Agenda HARB September 16, 2025

Item 2. 800 Park Place LLC
800 W 4th Street
64-002-101 1865 Herdic House-Park Home. Two story brick Victorian Hotel of the Italianate style. Paired brackets supporting eaves, decorative carved, arched lentils, and brick quoins. Large porches with arches. Designed by Eber Culver for Peter Herdic. Remodeled as Park Home 1940. Originally four stories, top two removed but retains integrity. Subject of a demolition State Preservation Law case. Park Home vs City Wmsport

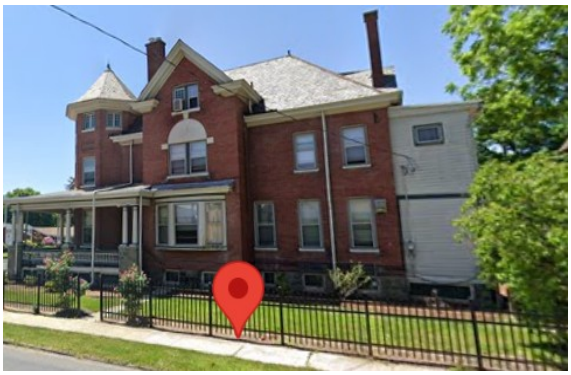
A. Remove steeply pitched iron exit stair on east side. Construct new stairs similar width but with a lesser rise. Build with P.T lumber stringers and risers and composite treads.
Finish with custom made wrought iron railings that match other rails on the building. See attached drawing.
B. Paint-colors: Same as previously approved, existing.

Possible Standards: #2….character of a property shall be retained and preserved. The removal of historic materials or alteration of features and spaces that characterize a property shall be avoided. #6...if severity of deterioration requires replacement of a distinctive feature, the new feature shall match the old in design, color, texture, and other visual qualities and, where possible, materials.
